Title		
Size	Number	Revision
A3		
Date:	3/12/2026	Sheet of
File:	C:\Users\...\BMS Architecture.SchDoc	Drawn By:

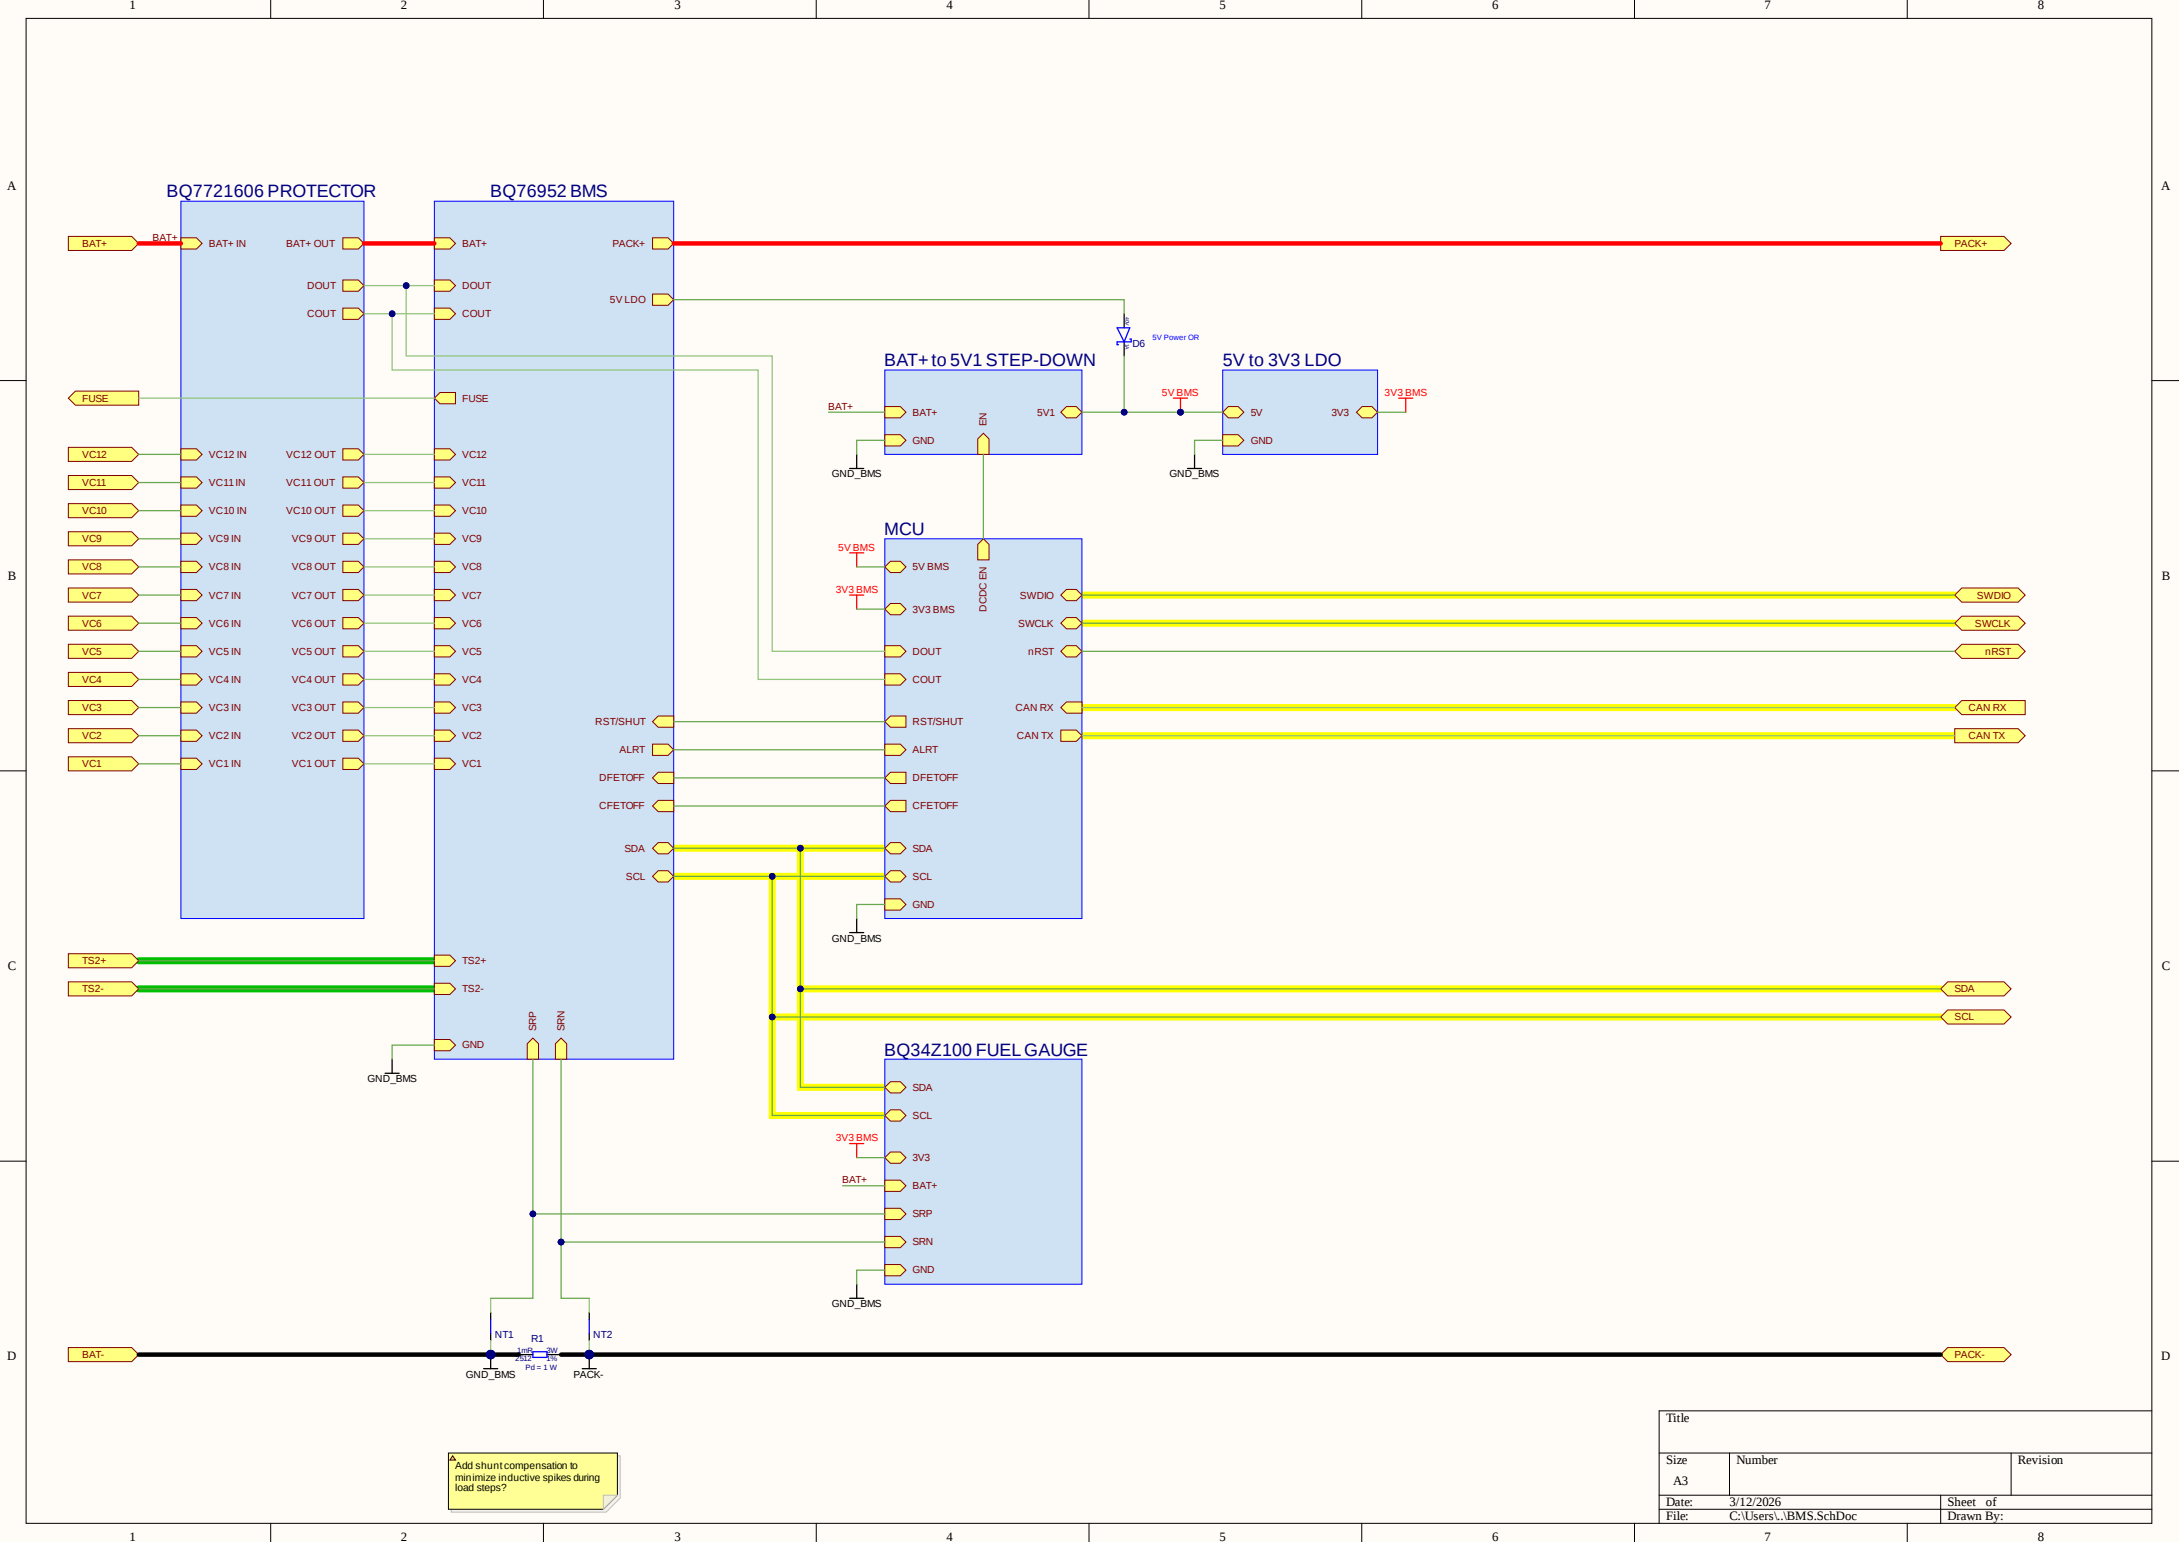
Add shunt compensation to minimize inductive spikes during load steps?
